CITY OF MILPITAS

Re: Integral Centre Pointe Mixed Use Project

Tentative Map Submittal

**Building Design Comments
 CENTRE POINTE LOTS B & C**

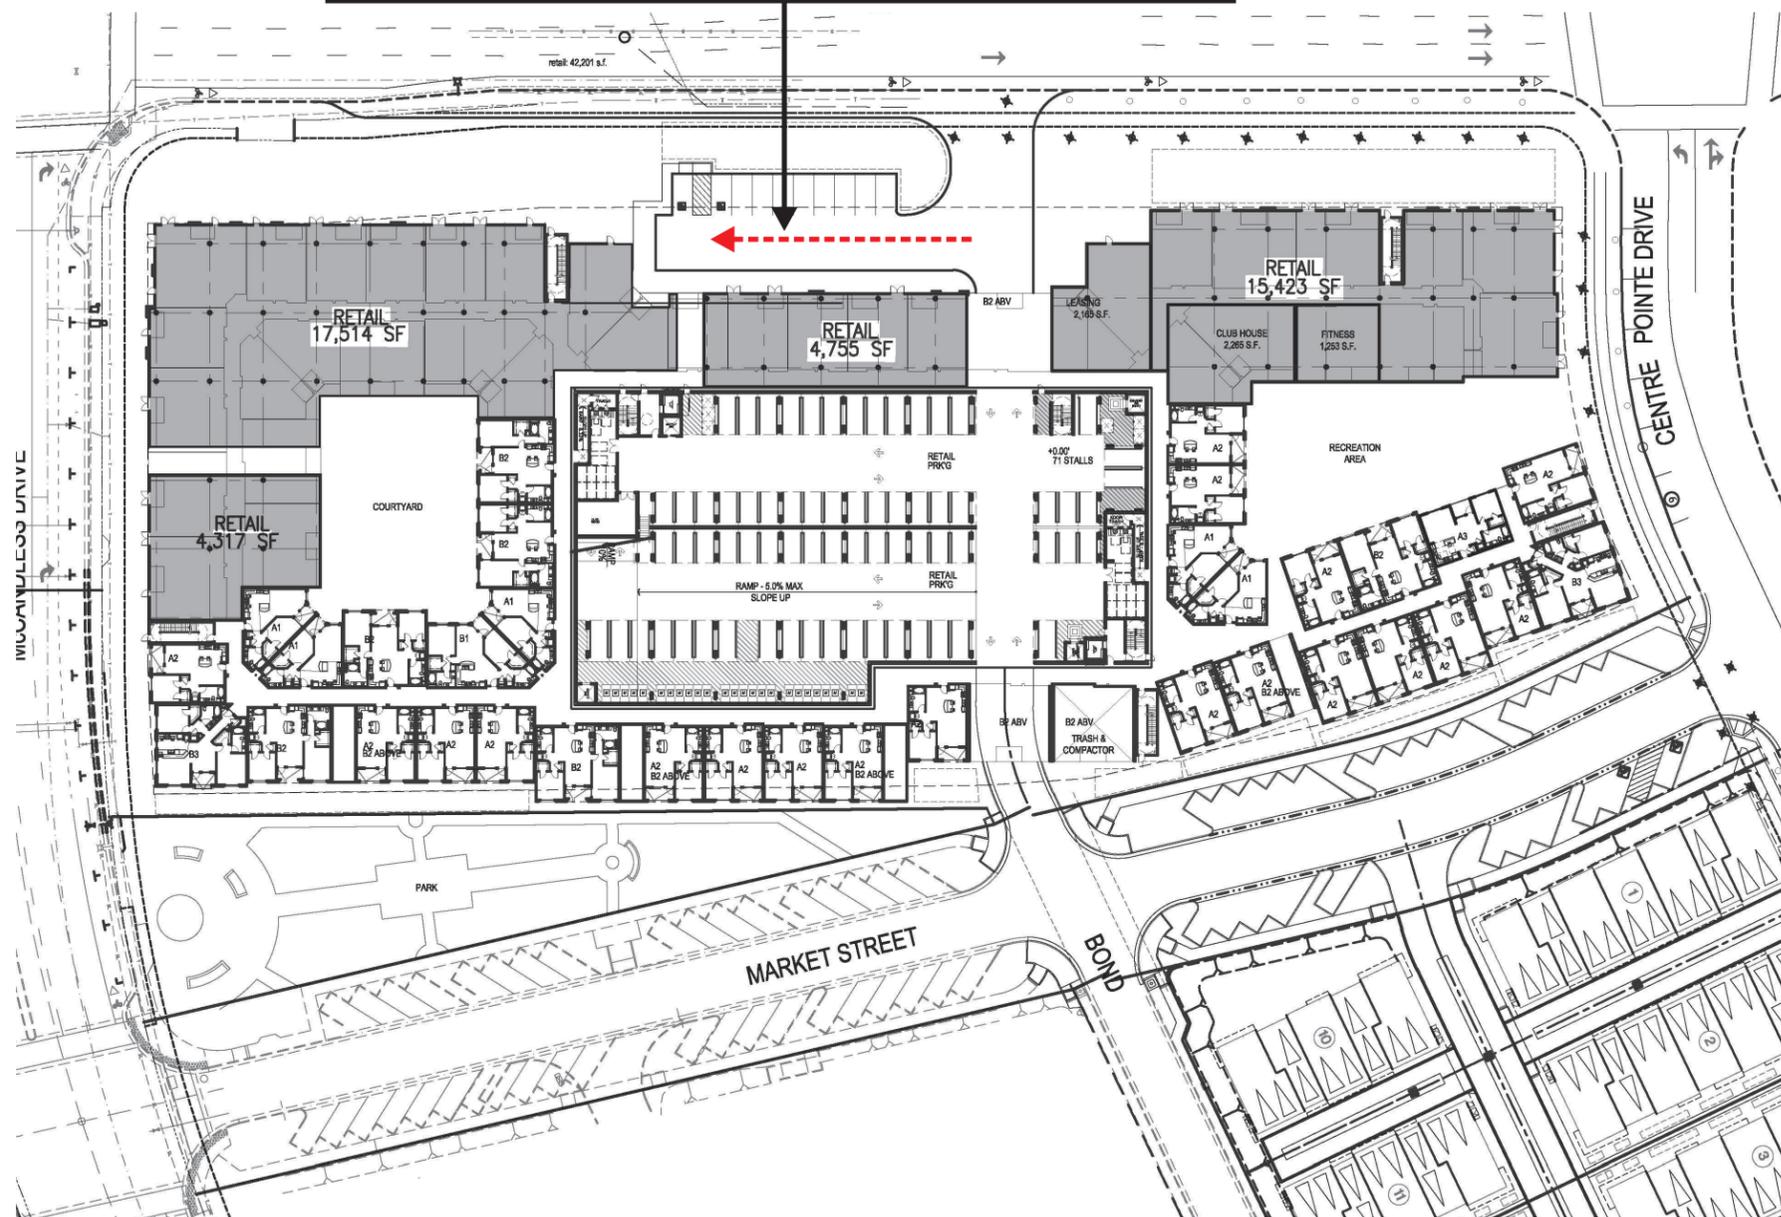
Rear walls and trellises make the building seem taller and more awkward

Rear elevations have long rows of unbroken garage doors and flat facades broken only by awnings
Residents will probably experience this environment more than the front elevations

Examples above show two ways to modulate the auto alley environment

Front elevations have good modulation and detail to provide feeling of individual units

Mixed Use Comments
CENTRE POINTE

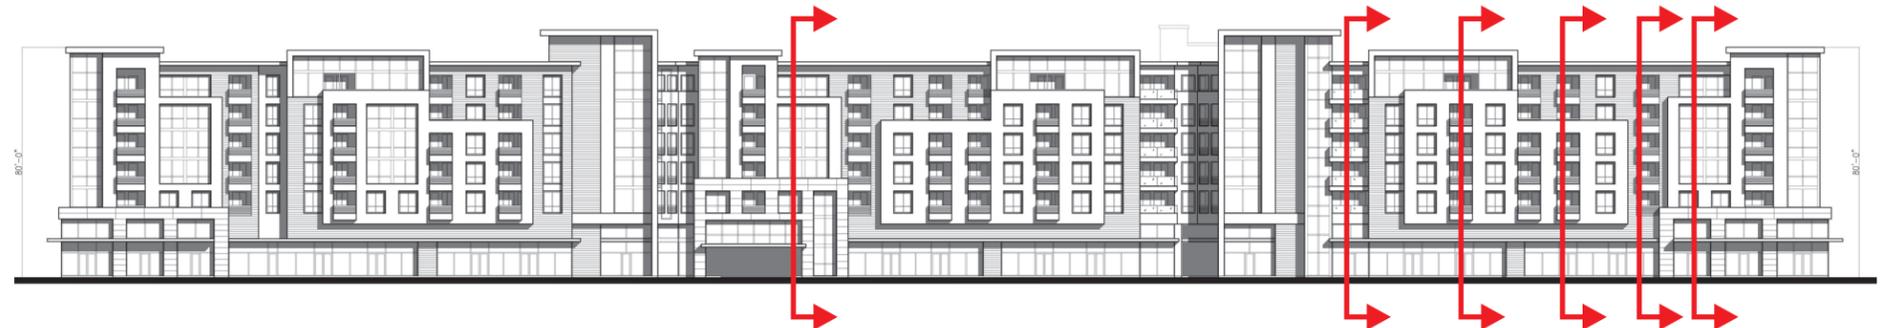
Dead end parking lots are not optimal
Parking for retail will be tempting.
Consider additional curb cut which would allow this to also be used a passenger drop-off area.

Very difficult to see from the drawings provided whether facades have significant wall plane offsets or whether it is mostly surface decoration
Several larger scale, accurate wall sections for all facades would be desirable.
